5.1. LOT 2 CAPTAIN COOK HWY, ANDREASSEN RD CRAIGLIE, ROL (1 INTO 32 RESIDENTIAL LOTS, PARK, DRAINAGE RESERVE ROAD AND BALANCE LAND)

REPORT AUTHOR(S)	Jenny Elphinstone, Senior Planning Officer
MANAGER	Paul Hoyer, Manager Environment and Planning
DEPARTMENT	Planning
PROPOSAL	Reconfiguring a Lot
APPLICANT	Port Douglas Land Developments Pty Ltd C/ Cardno (Qld) Pty Ltd PO Box 1619 Cairns Qld 4870
LOCATION OF SITE	L2 Captain Cook Hwy, Craiglie
PROPERTY	Lot 2 on SR431

Figure 6-2 Modelled Noise Barrier Location

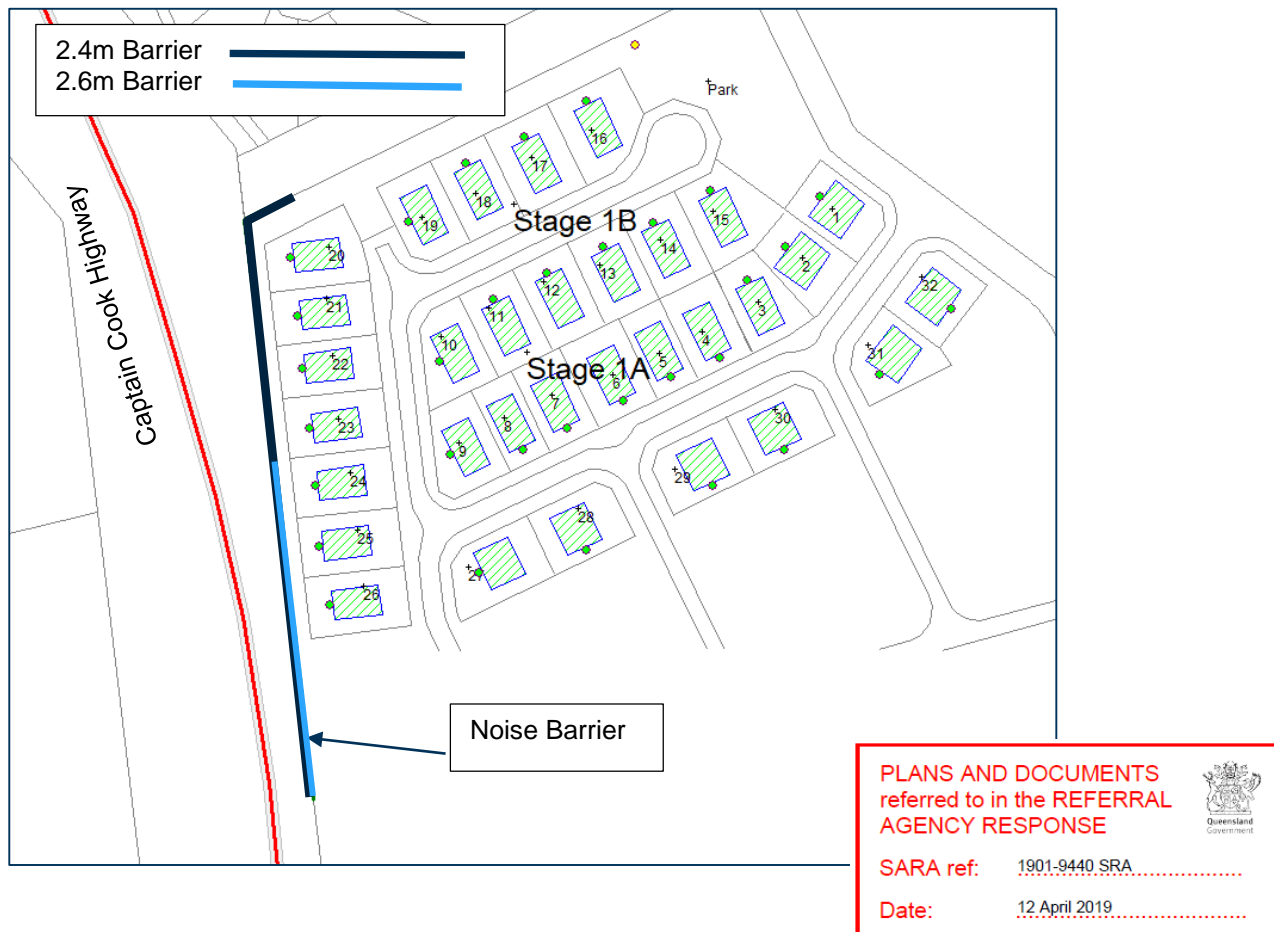
1.	(a) A 2.4 - 2.6 metre noise barrier must be constructed in the location shown in Figure 6-2 Modelled Noise Barrier Location of the Noise Impact Assessment Report, prepared by Cardno, dated 25 March 2019, reference I019_Q184013 (b) The noise barrier must be designed in accordance with: <ul style="list-style-type: none"> i. the Department of Transport and Main Roads' Road Traffic Noise Management Code of Practice, Volume 1, Chapter 6 and 7; ii. Specification MRTS15 Noise Fences (March 2019); and iii. Standard Drawing Road Manual, Part 13, Number 1606. (c) RPEQ certification must be provided to Corridor Management Unit, Department of Transport and Main Roads, Far North Queensland Region at Far.North.Queensland.IDAS@tmr.qld.gov.au , confirming that the development has been constructed in accordance with parts (a) and (b) of this condition.	Prior to submitting the Plan of Survey to the local government for approval and to be maintained at all times.
